Access Compliance Report

Public Rights-of-Way

Intersection ID: 6220	Main Street: NEAL_RD	Cross Street: RUMSTONE_LN	Location:	N
ADA ID: 499DA8EAE6DA	Ramp Type: PerpDiag	Initial Pass/Fail: Fail	Overall Compliance: No	Severity Score: 21.25

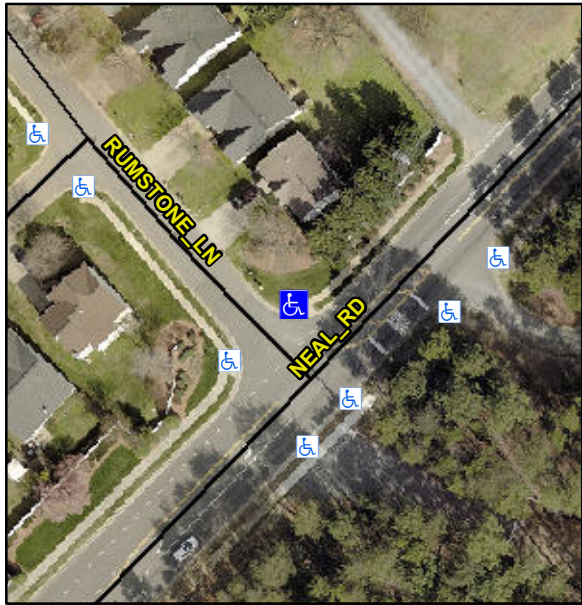
Codes/Mitigation Info/Possible Solution			Field Measurements/Component Compliance					
	Possible Solutions:		Compliance	Description	Data	Compliance	Description	Data
	Remove & Replace Curb Ramp With Two New Directional Ramps or Equivalent.		N/A	Ramp Length (in)	93.0	No	Ramp Slope (%)	9.5
			No	Ramp Width (in)	46.0	Yes	Ramp XSlope (%)	1.4
			N/A	Flare Type LT	N/A	N/A	Flare Type RT	N/A
			N/A	Flare Slope LT (%)	N/A	N/A	Flare Slope RT (%)	N/A
			N/A	Flare Traversable LT?	N/A	N/A	Flare Traversable RT?	N/A
			N/A	Landing Length (in)	N/A	N/A	DWS Provided?	N/A
			N/A	Landing Width (in)	N/A	N/A	DWS Contrast?	N/A
			N/A	Landing Slope (%)	N/A	N/A	DWS Length (in)	N/A
			N/A	Landing X Slope (%)	N/A	N/A	DWS Full Width?	N/A
Surveyor Notes:		N/A	N/A	Landing Curb? (Y/N)	N/A	N/A	DWS Offset (in)	N/A
PROW/ADA:		Not Found, R304.5.1, R304.2.2	N/A	Shared Landing?	N/A			
			N/A	Gutter Ponding?	N/A	N/A	Gutter Slope (%)	N/A
			N/A	Gutter Lip Ht (in)	0.5	N/A	Gutter X Slope (%)	N/A
